EXHIBIT B

LICENSE AMENDMENT REQUEST
DATED MARCH 20, 1978

This Exhibit consists of the following pages revised to incorporate all of the proposed Technical Specification changes:

Figure TS B-2.4-1. Off-Gas Storage Tank Gross Activity Limits

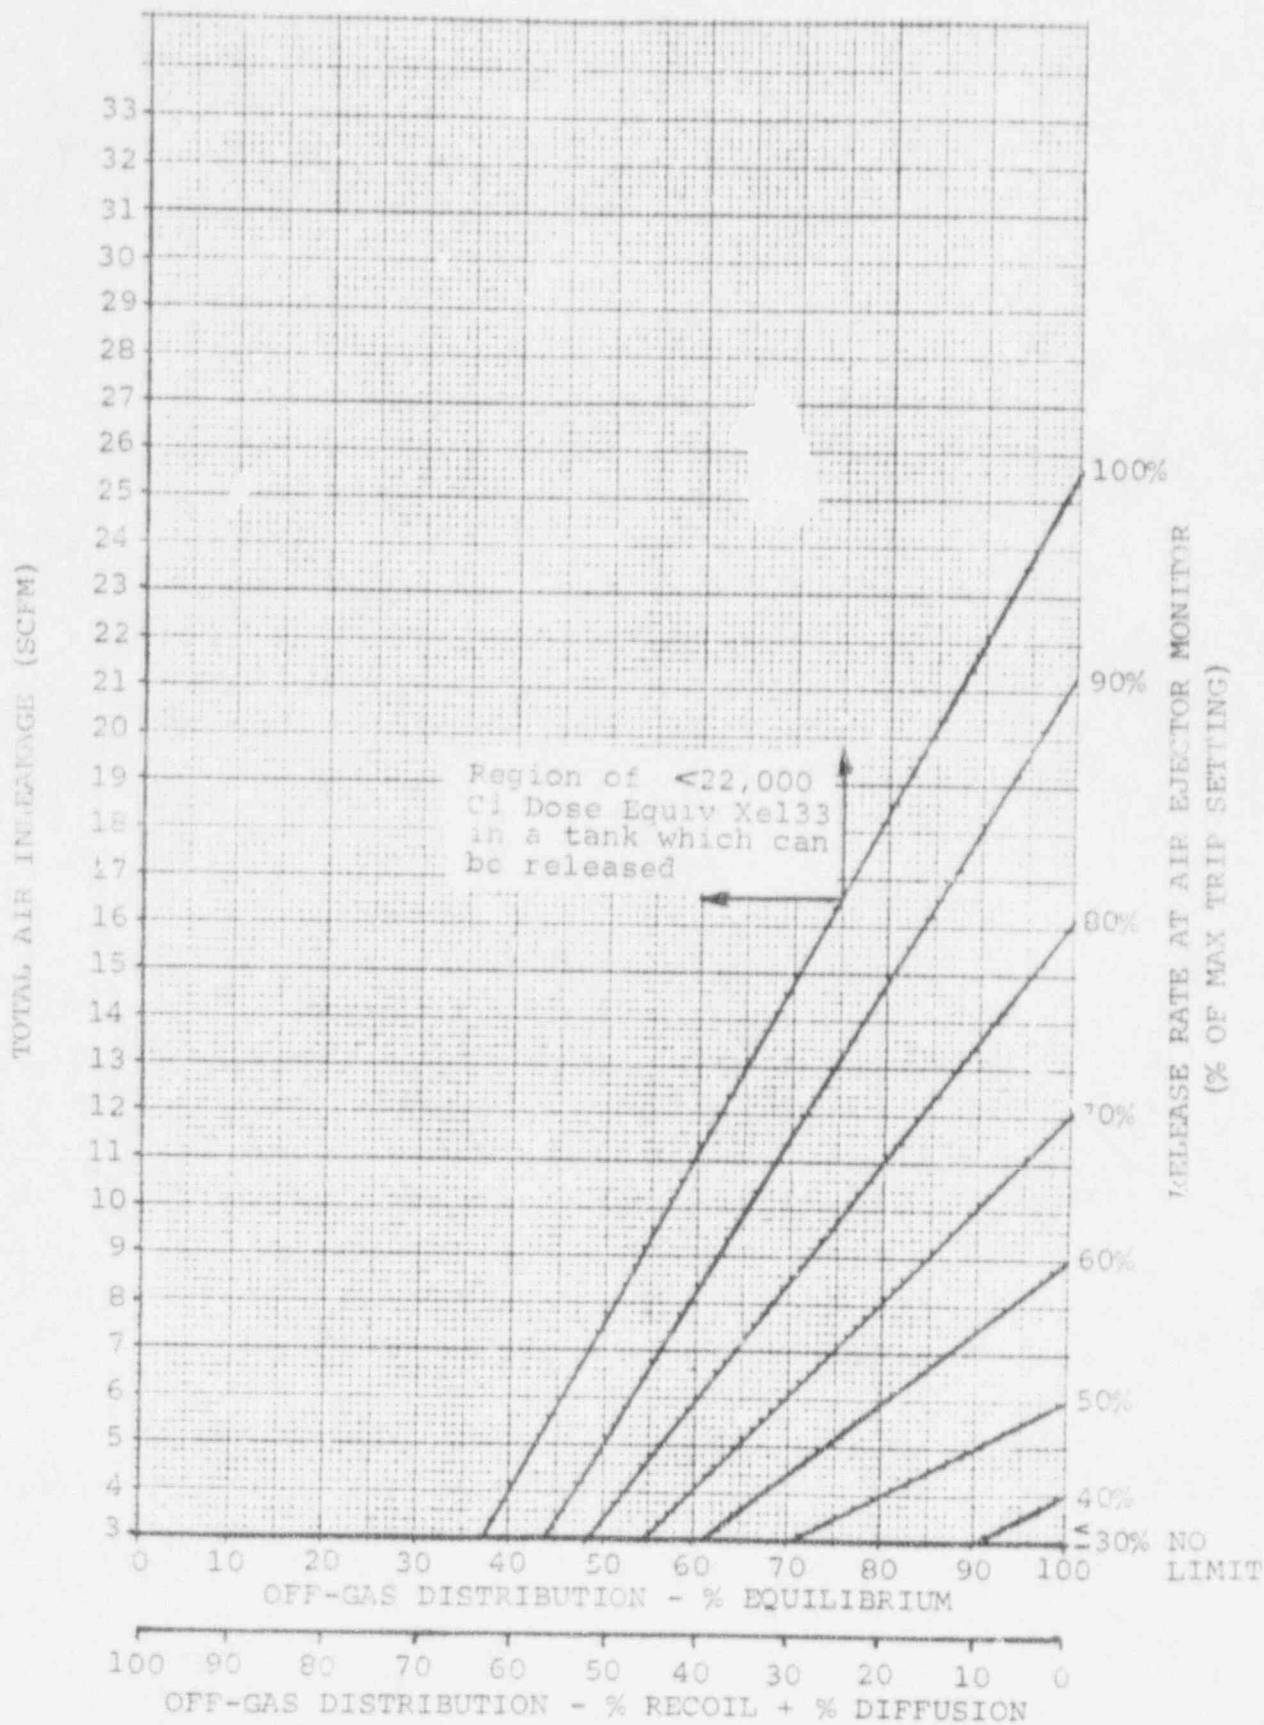
Calculations have been performed to determine the relationship between steam jet air ejector offgas activity and composition and condenser air inleakage. These calculations were used to determine the curves presented in Figure 2.4-1. The results of the measurement of condenser air inleakage and the average air ejector offgas release rate are used in conjunction with the

- d. The continuous effluent monitors listed in Table 2.4.4 shall be calibrated at least quarterly by means of a known gaseous or solid radioactive source which has been calibrated to a National Bureau of Standards source. Each monitor shall have a functional test at least monthly and an instrument check at least daily.
- e. Sampling and analysis of radioactive material in gaseous waste, including particulate forms and radioiodines shall be performed in accordance with Table 2.4-2.
- f. The hydrogen monitors shall be functionally tested monthly and calibrated quarterly with an appropriate gas mixture source. Each monitor shall have a sensor check at least daily.
- g. Condenser air inleakage shall be evaluated weekly and used in conjunction with steam jet air ejector offgas isotopic analyses and Figure 2.4-1 to determine that the limit of Specification 2.4.3.j is not exceeded.
